Project	IEEE 802.16 Broadband Wireless Access Working Group < http://ieee802.org/16 >	
Title	Comments on new Multicarrier text in SDD	
Date Submitted	2008-07-15	
Source(s)	Ken Stanwood – NextWave Wireless	Voice: +1-858-480-3327 E-mail: kstanwood@nextwave.com
	Mo-Han Fong – Nortel	E-mail: mhfong@nortel.com
	Jaehee Cho – Samsung	E-mail: jaehee1.cho@samsung.com
	Kamran Etemad – Intel	E-mail: Kamran.etemad@intel.com
	Naftali Chayat – Alvarion	E-mail: naftali.chayat@alvarion.com
	I-Kang Fu - MediaTek	E-mail: IK.Fu@mediatek.com
Re:	Call for Comments and Contributions on Project 802.16m System Description Document (SDD)	
Abstract	This contribution addresses the newly added multicarrier text in sections 11.6.4 and 19 of the 802.16m SDD.	
Purpose	Discuss as part of SDD call for comments and contributions and consider for adoption	
Notice	<i>This document does not represent the agreed views of the IEEE 802.16 Working Group or any of its subgroups. It represents only the views of the participants listed in the “Source(s)” field above. It is offered as a basis for discussion. It is not binding on the contributor(s), who reserve(s) the right to add, amend or withdraw material contained herein.<

Figure 1 Sub-carrier alignment by applying a fraction of sub-carrier spacing to the FA of adjacent frequency channel

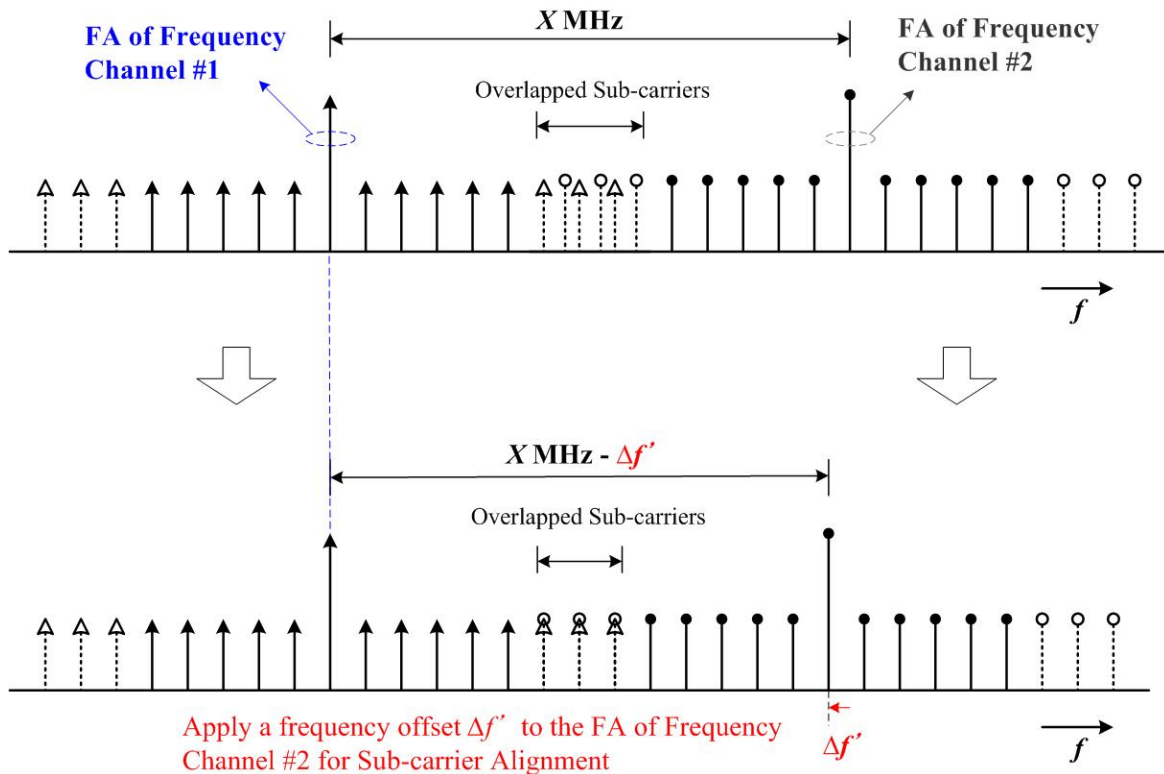
Move the opening text starting here and ending just prior to section 19.1 into a new section “19.2 Subcarrier Alignment for Utilization of Guard Subcarriers of Adjacent Frequency Channels”.
